**73, 77 & 83 Linton Street, Kangaroo Point
QLD 4169**

**Request to Change a Development Approval under s81 of the Planning Act 2016:
Development Permit for a Material Change of Use & Building Work – Multiple
Dwellings (Council Reference: A006350800)**

On behalf of
JK Apartments Pty Ltd

July 2026

Figure 3 Comparison of Ground Level Landscaping
 Source: Excerpt from amended Landscape Concept Plans attached under Appendix B

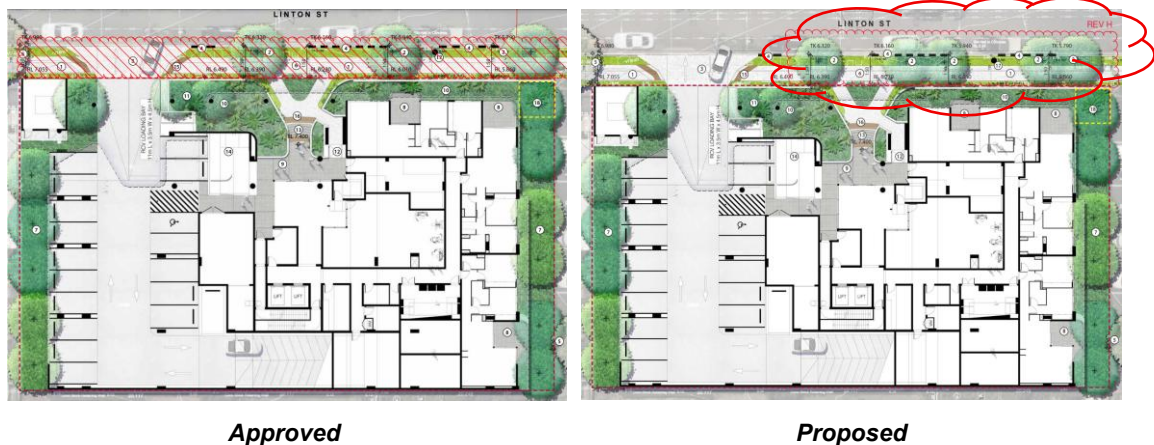
Deep planting and landscaping throughout the development is generally maintained in accordance with the current approval. However, it is proposed to modify the street tree arrangement as illustrated on the updated Landscape Concept Plan attached under **Appendix B**.

The revised street tree arrangement includes two (2) additional street trees, bringing the total tree count to five (5) trees along the Linton Street frontage (**Figure 3**). The addition of these trees results in an increase in the canopy extent and shade coverage across the site frontage, improving amenity for pedestrians and contributing to urban heat island mitigation. The increased tree count represents an improvement on the previous design and demonstrates the development’s commitment to enhancing the public domain and green infrastructure outcomes for the site.
